Meeting Notes

Date: March 19, 2024

Project NHDOT 16307
#: VHB 52792.00

Re: Jaffrey US 202 Dog-Leg Improvements
Public Informational Meeting #3

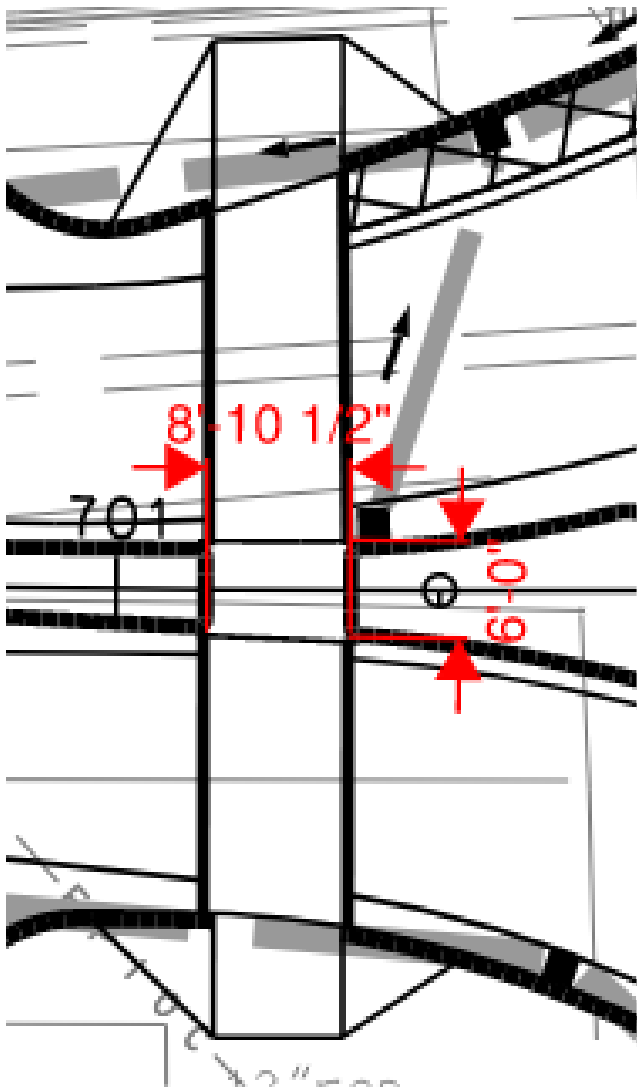
Question was raised about the site distance for vehicles leaving the roundabout to the crosswalks as typically drivers speed up when exiting a roundabout.

Yes, the proper sight distance is provided for this area in all locations. VHB coordinated with Toole Design to ensure proposed landscaping does not hinder sight distance at these locations.

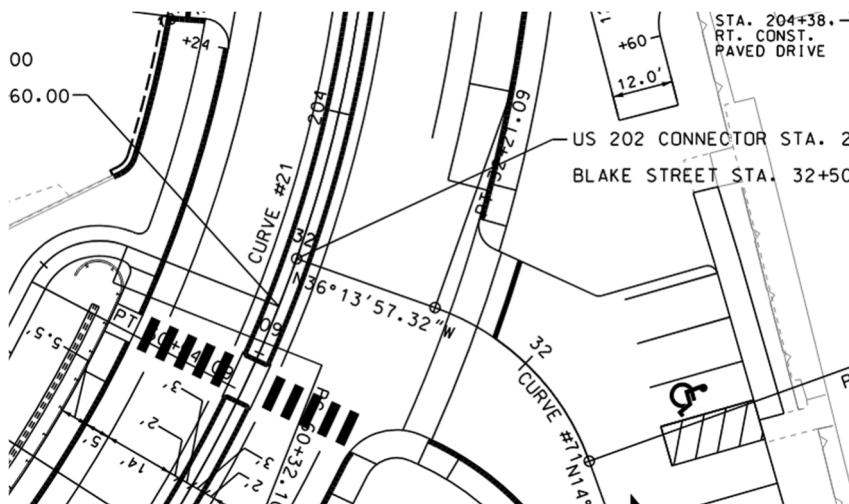
Question was raised if an emergency vehicle could take a left across the median from the Connector Road heading south to Blake Street during an emergency.

Yes, the 6" raised median island has sloped curb on each side that is mountable by an emergency vehicle and the team will review the plans to ensure no signs or landscaping are in this area.
